DAWN MINING COMPANY  
PO BOX 25  
FORD, WASHINGTON 99010

March 10, 1981

Enclosed are revisions to the seepage detection system originally submitted to you on February 4, 1981. These changes are in response to verbal communications with Mr. Dan Guillen and Mr. Roy Williams of the N.R.C.

PLOT PLAN & LAYOUT OF LYSIMETER INSTALLATIONS

FIGURE 2 (REVISION #2)  
4 MARCH 1961

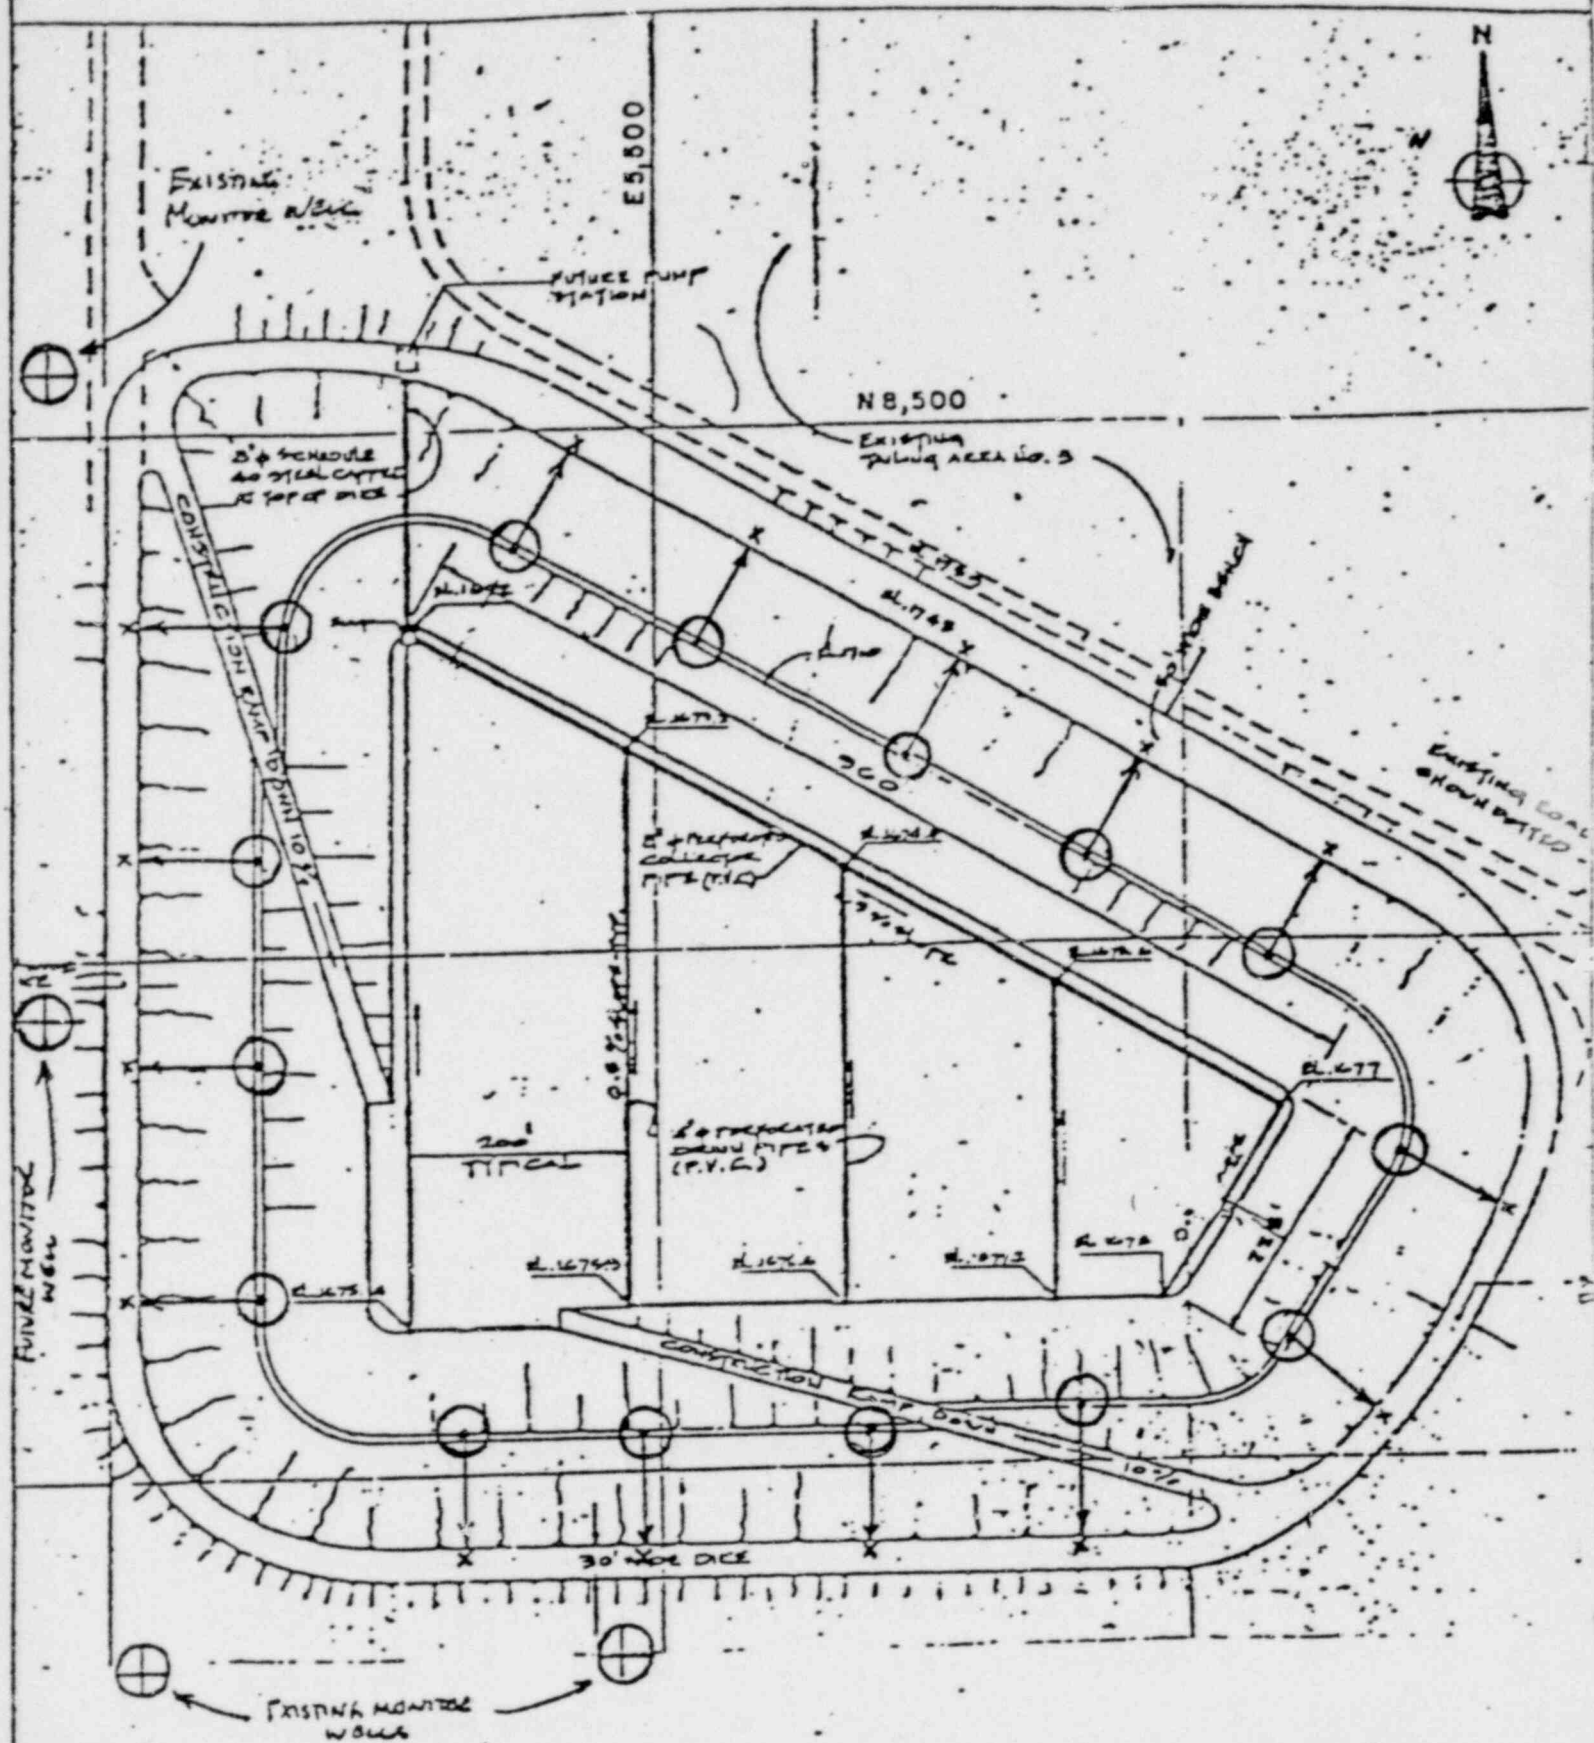
1. The original design of ten Lysimeters in five holes has been changed to fifteen Lysimeters in fifteen Holes. (see figure #2)
2. The network has been moved to concentrate on the slopes, where failure is most likely to occur. (see figures 1 & 2)
3. The depth of the Lysimeters has been changed.

NOTE: WHERE BASALT IS ENCOUNTERED  
 IN THE LYSIMETER HOLE,  
 THE INSTRUMENT SHALL BE  
 INSTALLED AT THE SAND/  
 BASALT INTERFACE.
